Preliminary Information

PIT5825A Vibration Type Noise Heard at Highway Speeds

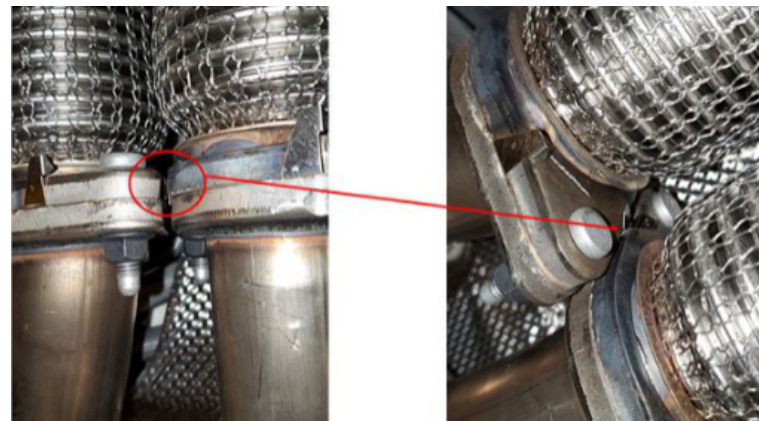
Involved Region or Country	North America
Condition	Vibration type noise at highway speeds heard under the vehicle.
Cause	Some of the metal gasket tabs between the front exhaust and muffler are not fully crimped, exhibiting some spring-back, allowing for them to touch at certain speeds / rpms

With a small punch or chisel and hammer bend/crimp the tabs on the exhaust gasket in further to prevent any spring-back and provide increased clearance between the two tabs to correct the noise.
